# Product Change Notification

**Change Notification #:** 111925 - 01  
**Change Title:** DC3217IYE, Boxed  
PCN 111925-01, Product Design  
Updates to BIOS and PBA  
**Reason for Revision: Remove Reference to Px and Py on PBA Change**  
**Date of Publication:** December 07, 2012

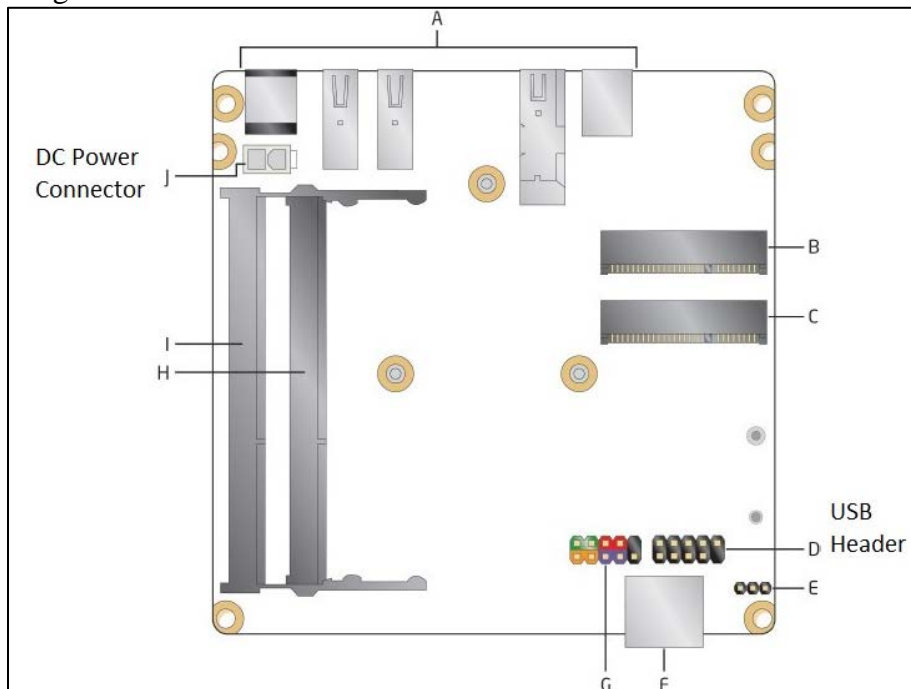
1. The BIOS will be updated to GKPPT10H.86A.0032. To access the release notes or get a copy of the BIOS for evaluation, go to <http://downloadcenter.intel.com>.
2. A DC power connector and USB header will be added to the PBA. See the following image:
